FCC Class II Permissive Change Application Letter

Product name : Portable Photo Printer, Instant Print Camera

FCC ID: 2AUTE-2TS24E

Model No.: HCP-2TS24E, Z3

Appearance

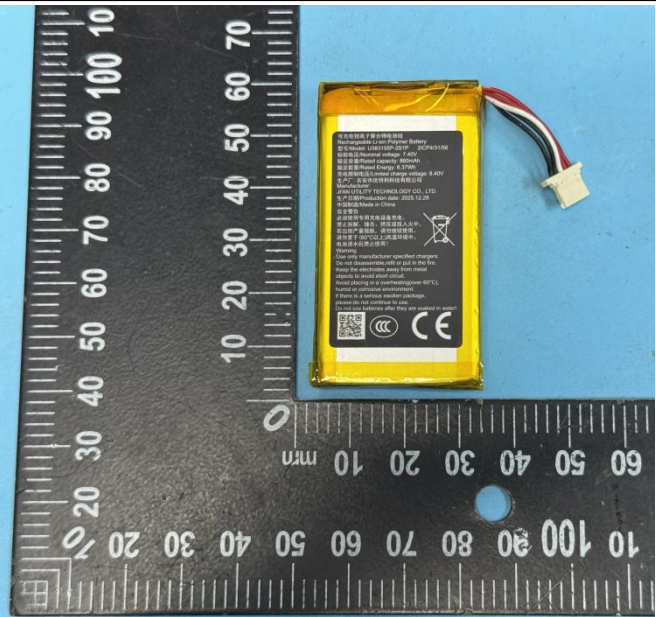
Change Contents: update the components on Product as below:

Li-ion Polymer Battery Model: 404057-2S 7.4V, 1150mAh Huizhou superstar Technology Co., Ltd	Battery 1# Li-ion Polymer Battery Model: 404057-2S 7.4V, 1150mAh Huizhou superstar Technology Co., Ltd Battery 2# Rechargeable Li-ion Polymer Battery Model: U383155P-2S1P 7.4V, 860mAh JI'AN UTILITY TECHNOLOGY CO., LTD.

Main Board

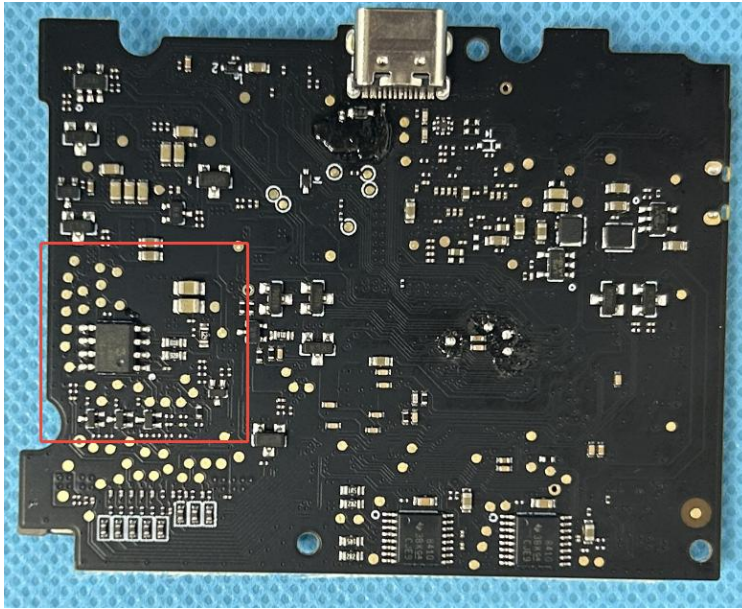
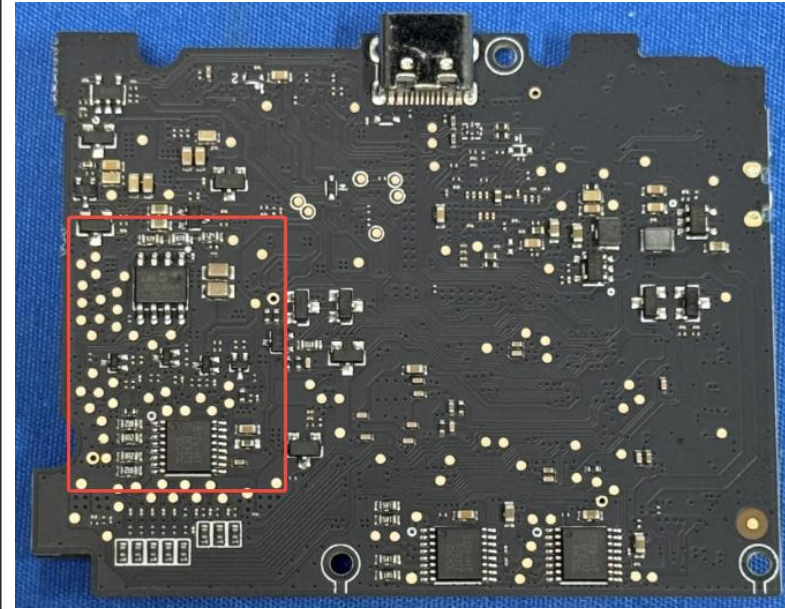
Battery model: U3831559-2S1P Compared to battery model: 401057-2S, it has added the motor drive chip and its surrounding circuits.
